<b>Project Owner:</b>	Rockford Public Schools
<b>Project Name:</b>	Edgerton Trails Elementary School Technology
<b>Issue Date:</b>	September 28, 2023

## ADDENDUM NO. 1

<i>Bid ID: 3021</i>	Communications by Design, Inc.
<i>Addendum #1 Issued: October 16, 2023</i>	<i>Proprietary Information – All Rights Reserved</i>

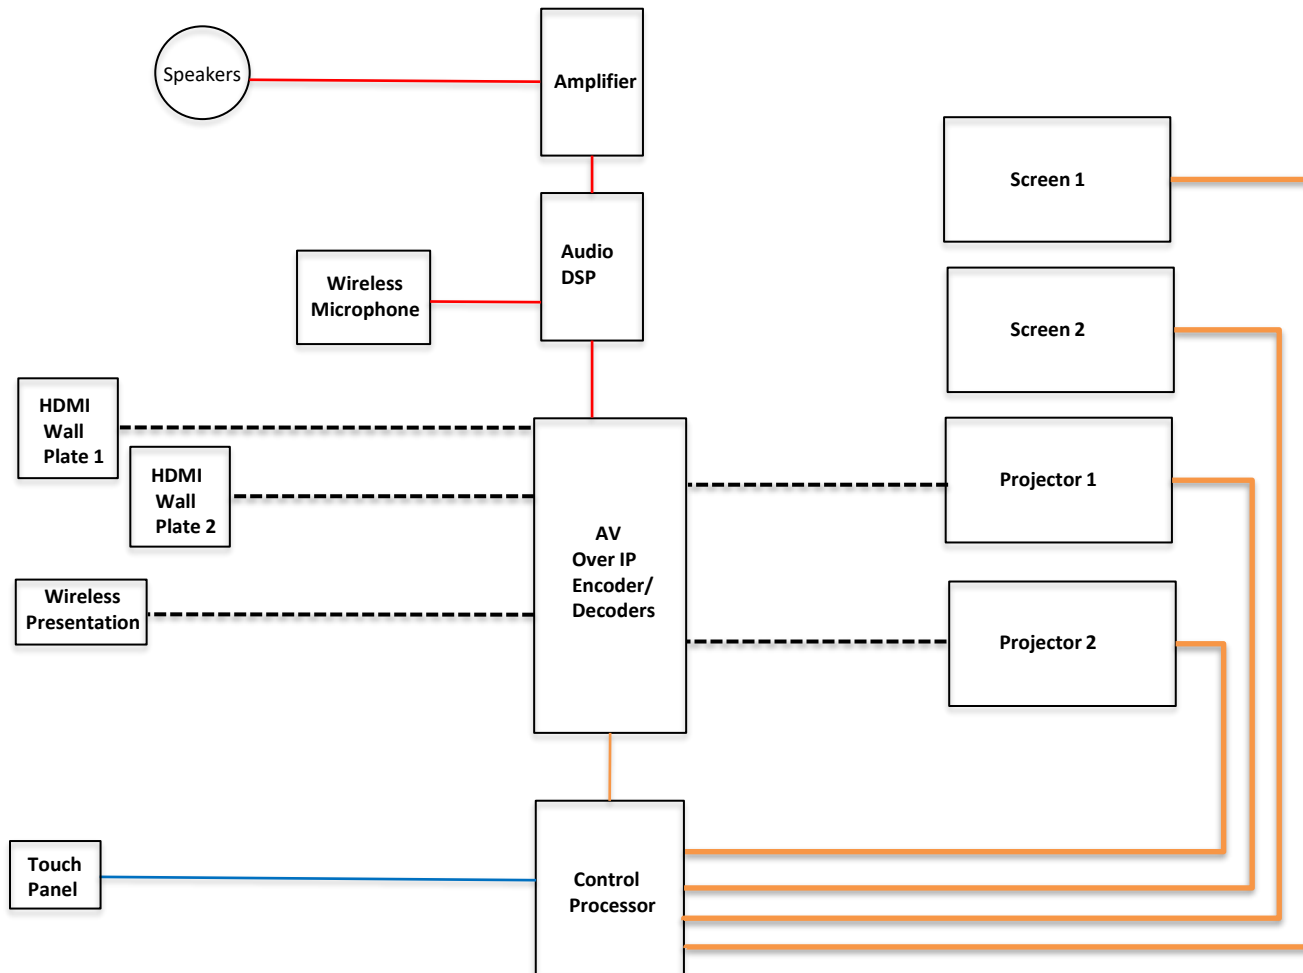
<b>AD1 - 1</b>	<p>Configuration D is hereby revised as follows:</p> <p>1.01 Configuration D</p> <p>A. Contractor shall supply one (1) of the specified configurations in the following locations. Contractor to supply, configure and install all mounts, cables and connections for a complete installation.</p> <ol style="list-style-type: none"> <li>1. Conference Room B114</li> </ol> <p>B. One (1) LED Monitor(s)</p> <ol style="list-style-type: none"> <li>1. Acceptable Manufacturer(s) <ol style="list-style-type: none"> <li>a. SAMSUNG - QB65R</li> </ol> </li> <li>2. Contractor shall supply and install appropriate mounts for supplied LED monitors, one (1) flat mount Peerless SF660P or Chief equivalent shall be provided for each monitor. See drawings for location.</li> <li>3. Monitor shall be configured to automatically turn on with the connection of an active HDMI source. Monitor shall be controlled via supplied Crestron processor to change inputs using Crestron TT-100 table pocket buttons.</li> </ol> <p>C. One (1) Cable Caddy shall be provided and installed.</p> <ol style="list-style-type: none"> <li>1. Acceptable Manufacturer(s)</li> </ol>

<ul style="list-style-type: none"> <li>a. CRESTRON – TT-100-B-T</li> <li>2. Cable Caddy shall include connections for two (2) HDMI cable connections. Contractor shall supply all necessary cables and accessories for a fully functional system.</li> <li>D. Two (2) Multimedia Extension Device Pair(s) shall be provided and installed. <ul style="list-style-type: none"> <li>1. Acceptable Manufacturer(s) <ul style="list-style-type: none"> <li>a. CRESTRON <ul style="list-style-type: none"> <li>1. HD-TX-4KZ-101/HD-RX-4KZ-101 – Pair</li> <li>b. 4K60 4:4:4</li> <li>c. HDR10+</li> <li>d. HDCP 2.3</li> <li>e. Cable length up to 130’.</li> </ul> </li> <li>2. Contractor shall supply all necessary cabling and accessories to mount transmitters at conference table location and make fully functional.</li> </ul> </li> <li>E. One (1) Control Processor shall be provided and installed. <ul style="list-style-type: none"> <li>1. Acceptable manufacturer(s) <ul style="list-style-type: none"> <li>a. CRESTRON – RMC4</li> </ul> </li> <li>2. Contractor shall supply all necessary cables and accessories to integrate Control Processor device with Contractor supplied Cable Caddy and LED monitor. Control Processor shall be configured to switch HDMI channels on supplied monitor using Cable Caddy buttons.</li> </ul> </li> </ul> </li> </ul>
